DRAINAGE AND TRANSPORTATION INFORMATION SHEET
(Rev. 12/05)

PROJECT TITLE: Broadstone Santa Monica ZONE MAP/DRG.FILE# D-18-Z
DRB#: _____ EPC#: _____ WORK ORDER#: _____

Re: Broadstone Santa Monica—D18/D054

**Re: Broadstone Santa Monica Place
Grading and Drainage Plan
Engineer's Stamp dated 3-7-2012 (D18/D054)**

OVERFLOW WEIR AT CONCRETE STILLING BASIN @ NW CORNER

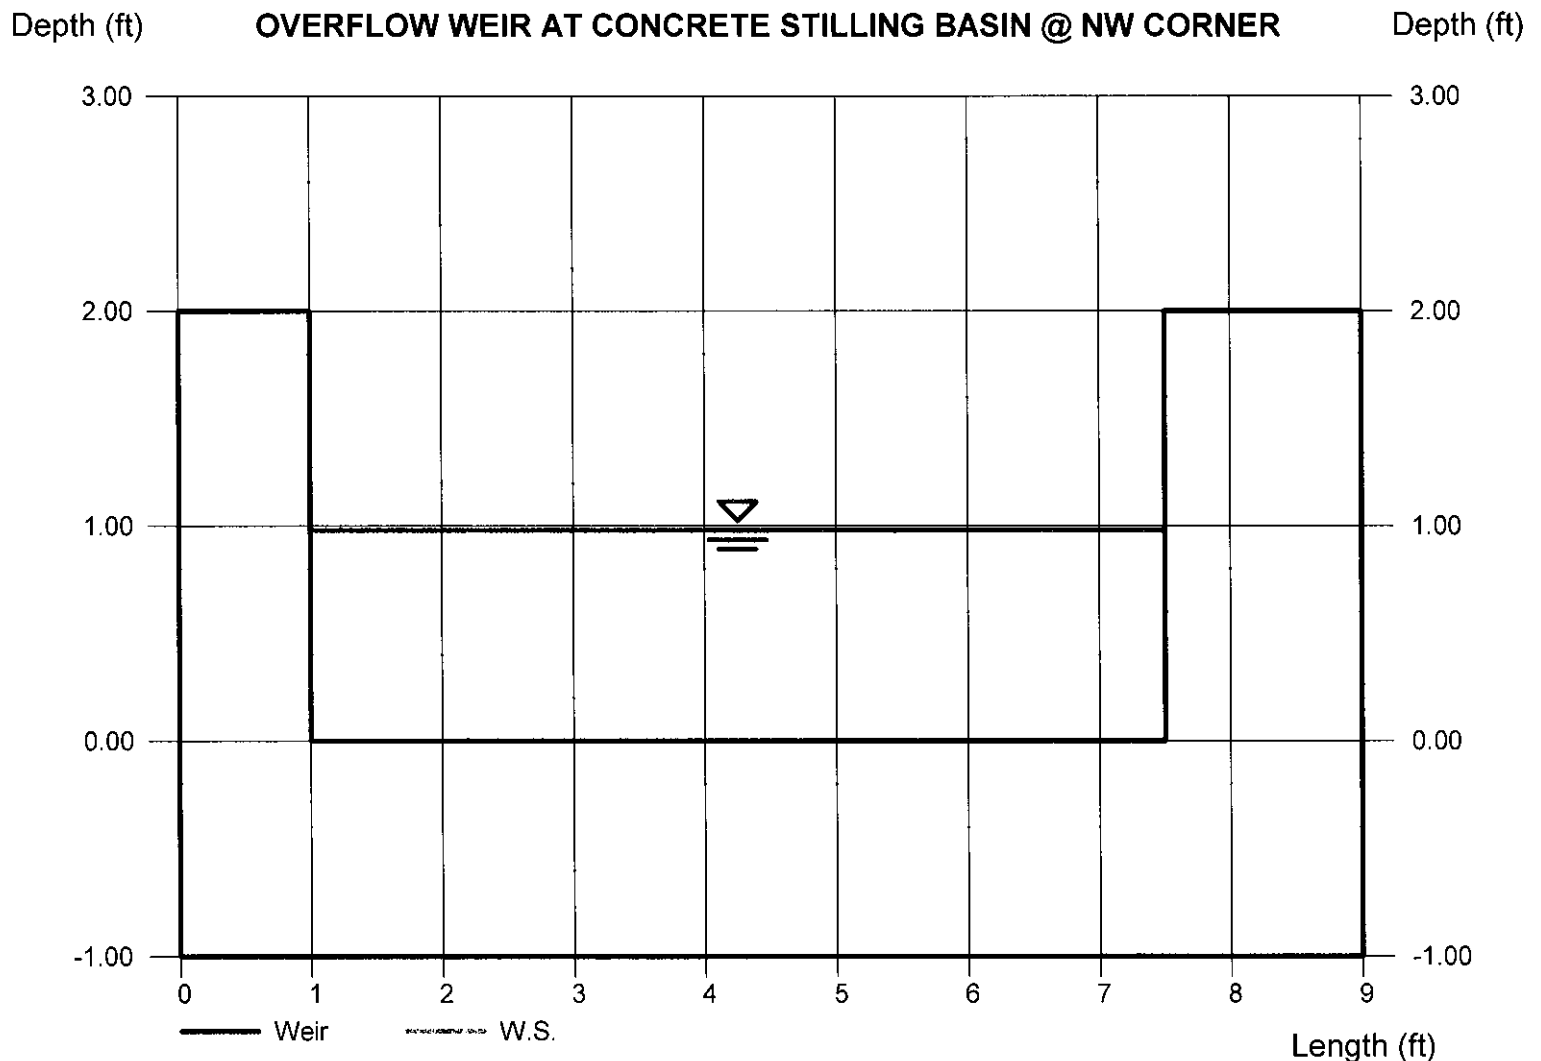
- Pond calculations are needed for the small pond just north of the entrance/exit on San Pedro. What is the WSE?
- How are the proposed contours tying in with the contours to the north of this site at the NW corner?
- Provide the direction of roof flows for the units in the NW corner. These flows should not drain over the sidewalk.
- Are all landscape areas being depressed as well as the areas with sidewalk culverts? Can the small islands in the parking lots contain a 1' cut in the curb to accept flows? This would assist in lowering the flows entering San Pedro for the first 6 hours and would also help with the new EPA regulations and the MS 4 permit coming in the near future.

1. The intent of the storm drain outfall structure is to dissipate the velocity of the storm drain discharge and overflow it to the south paved drive over a 6.5-foot wide weir. Flow remaining in the lower 6 inches will pass to the north via the proposed 4-inch drainline. The peak flow in the 4-inch pipe is 0.5 cfs and the remaining flows of 21.0 cfs discharges via the weir. See Supplemental Calculations for weir overflow and 4-inch orifice calculations. Based on these calculations, the water surface elevation will be 63.0—one foot above the flowline elevation. The curb adjacent to the weir will be 12 inches high with transitions to the top of wall elevation of 64.5.
